UNITED STATES
DEPARTMENT OF THE INTERIOR
BUREAU OF LAND MANAGEMENT

SUNDRY NOTICES AND REPORTS ON WELLS
Do not use this form for proposals to drill or to re-enter an abandoned well. Use Form 3160-3 (APD) for such proposals.

8. Well Name and No.
Big Eddy Unit 249H

BOPCO,L.P. is requesting approval to amend point 4 Pressure Control Equipment in the original APD as attached.

Latshaw 13-5/8" X 3-M BOPE (2 Rams and Rotating Head) & Closed Loop System Equipment Schematic Diagram 2

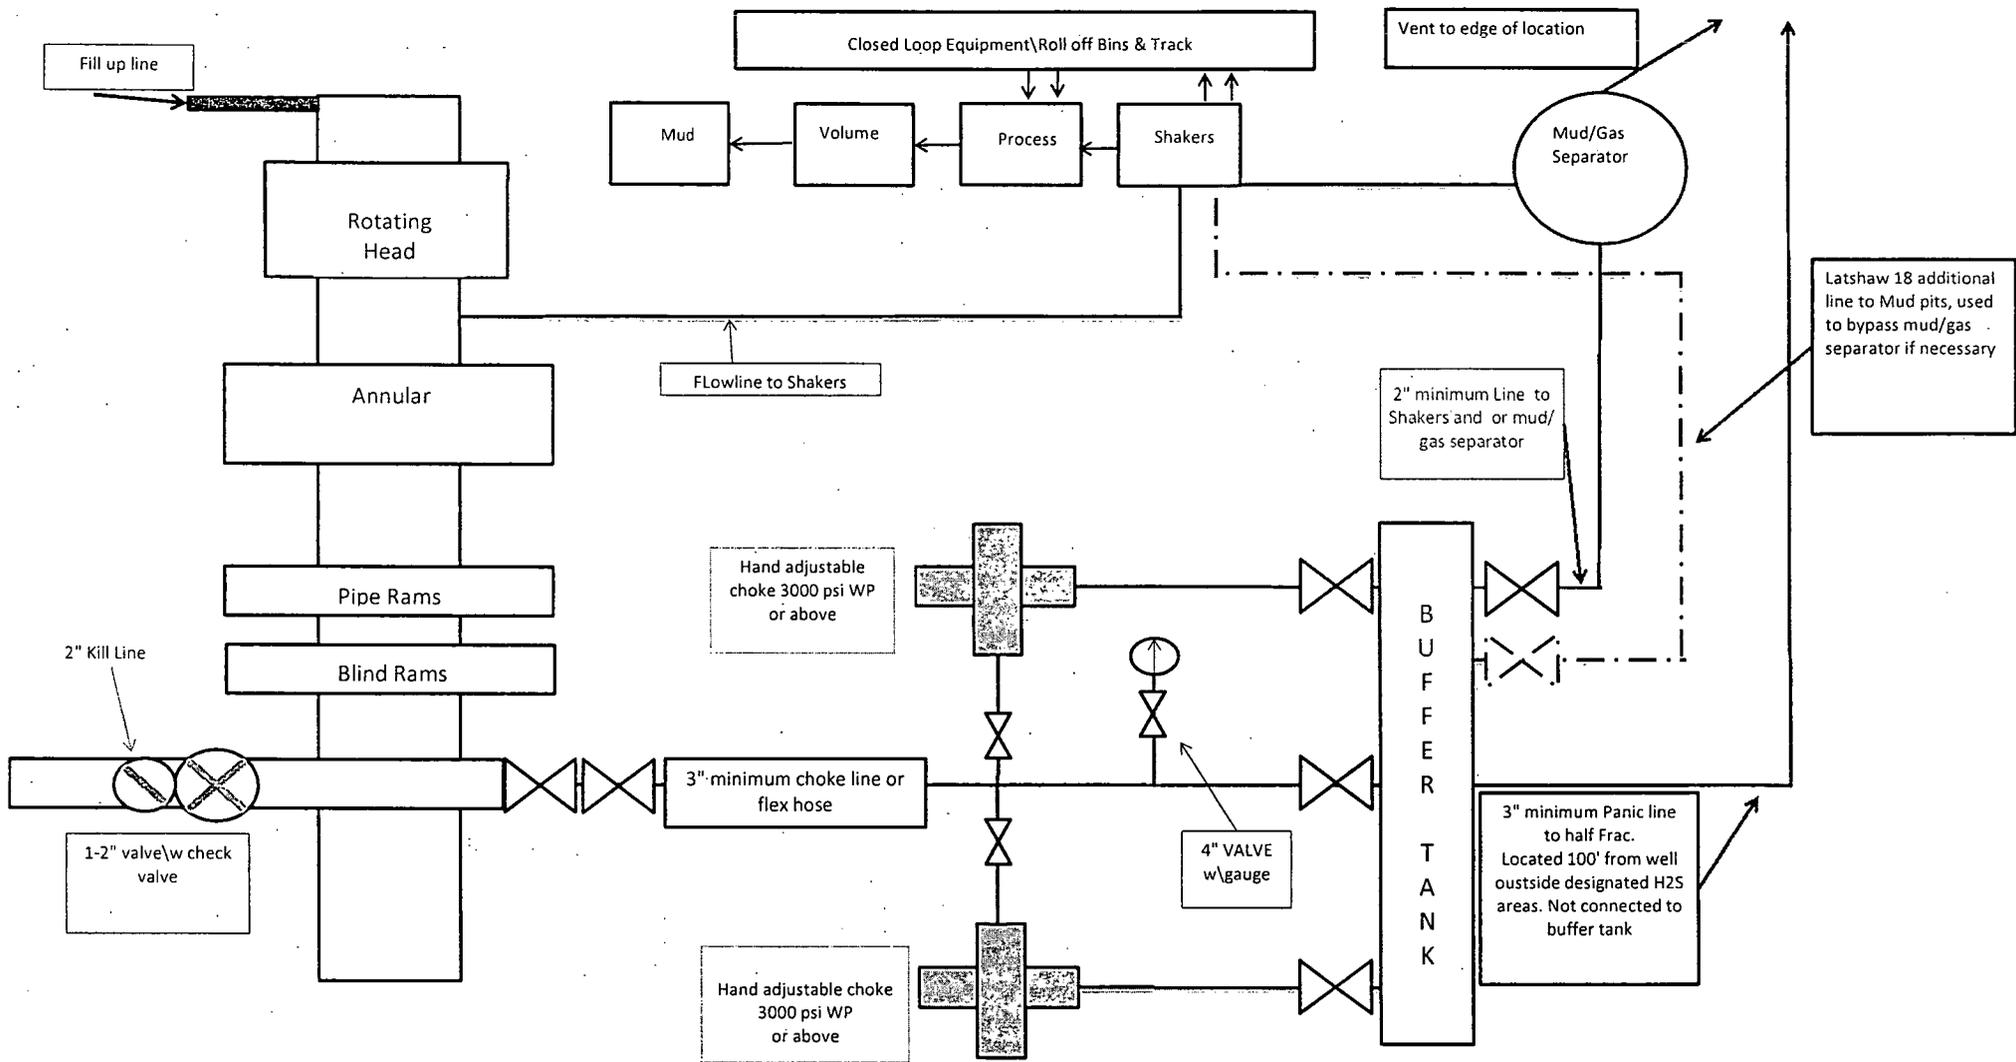
POINT 4: PRESSURE CONTROL EQUIPMENT (SEE ATTACHED DIAGRAM 2)

After running the 13-3/8" surface casing, a 13-5/8" BOP/BOPE system with a minimum rating of 3M will be installed, used, maintained and tested as per Onshore Order 2. In addition to the high pressure test, a low pressure (250-300 psig) test will be performed.

After running the 9-5/8" intermediate casing, a 13-5/8" or 11" BOP/BOPE system with a minimum rating of 3M will be installed on the 9-5/8" intermediate casing spool (8-3/4" open hole), used, maintained and tested as per Onshore Order 2. In addition to the high pressure test, a low pressure (250-300 psig) test will be performed.

After running the 7" intermediate casing, a 13-5/8" or 11" BOP/BOPE system with a minimum rating of 3M will be installed on the 9-5/8" intermediate casing spool (8-3/4" open hole), used, maintained and tested as per Onshore Order 2. In addition to the high pressure test, a low pressure (250-300 psig) test will be performed.

Latshaw 4 closed loop system, with Latshaw 18 addition "clouded."

13-5/8" X 3-M BOPE (2 Rams and Rotating Head) & Closed Loop System Equipment Schematic H2S contingency Diagram 2

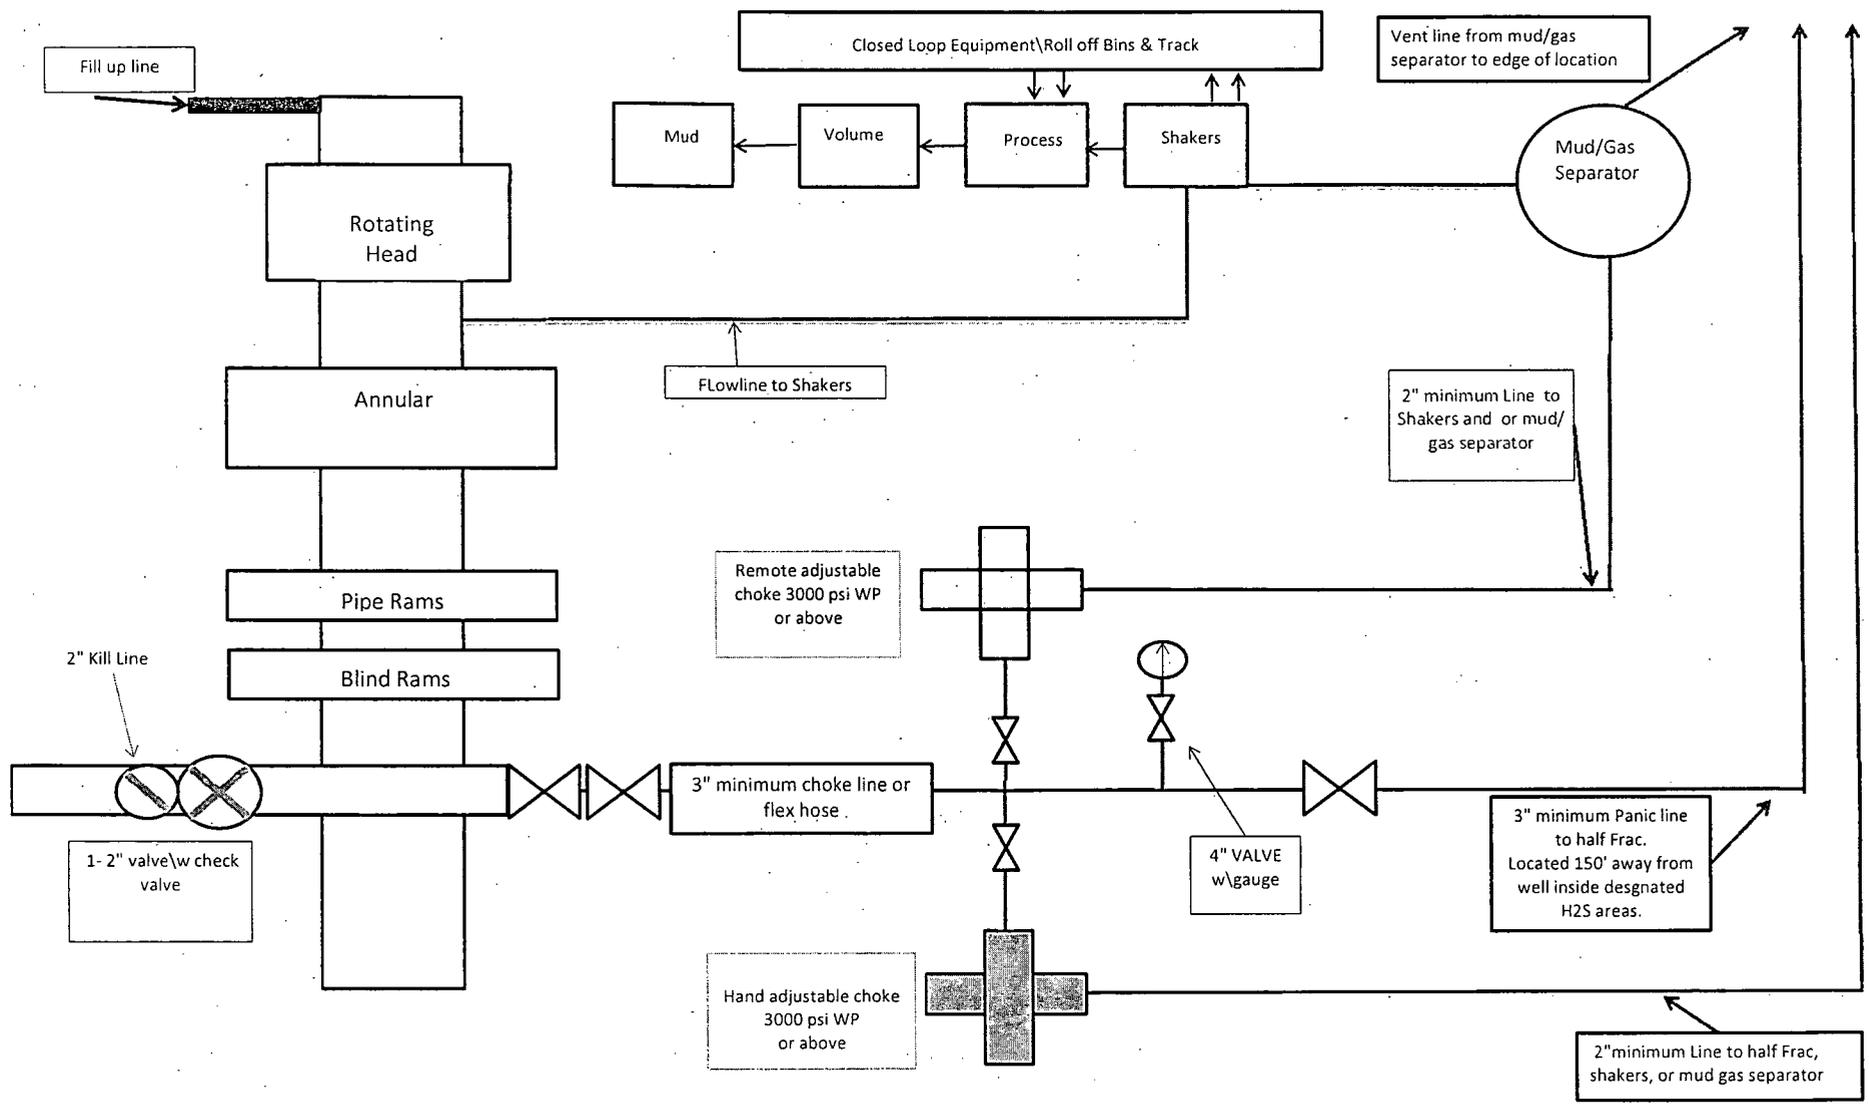
H2S monitors shall be installed prior to drilling out the surface shoe. If H2S is encountered in quantities greater than 10 PPM, the well will be shut in and H2S equipment will be installed, including a flare line that will be extended pursuant to onshore oil and gas order #6.

Latshaw 18 additional line to Mud pits, used to bypass mud/gas separator if necessary
